REMARKS

Attorneys for Intel Corporation

FIG. 1

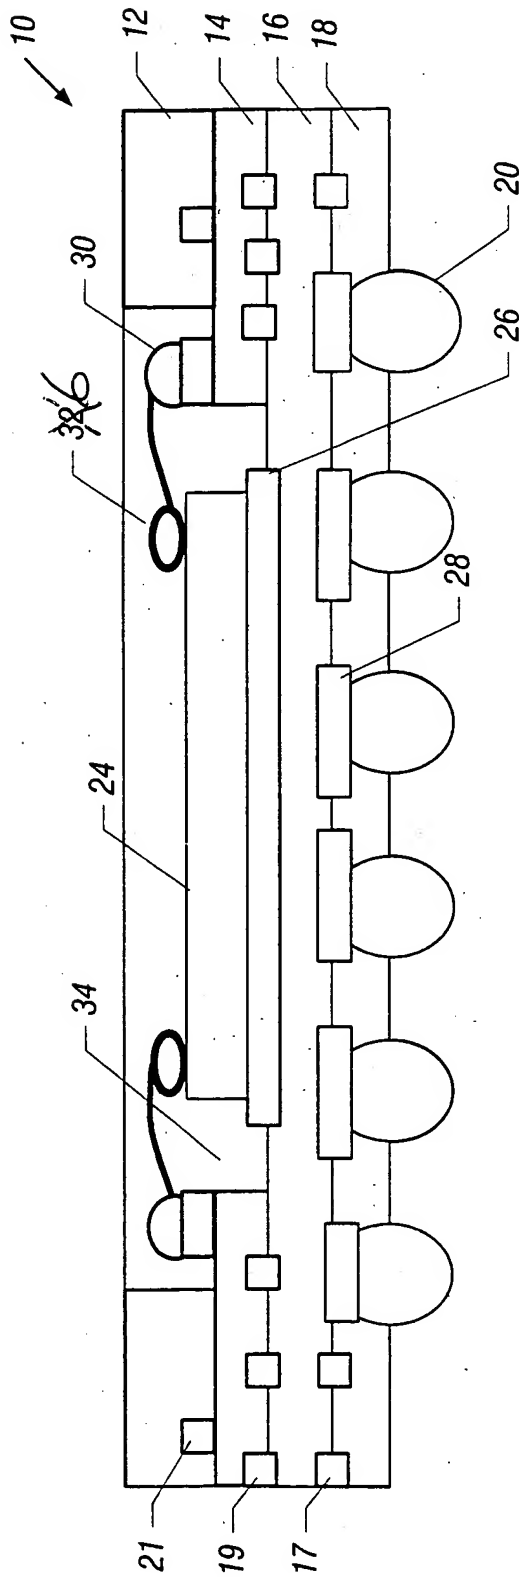
Figure 1 has been amended as indicated in red in the attached annotated marked-up drawing. A replacement sheet of Figure 1 is also attached.
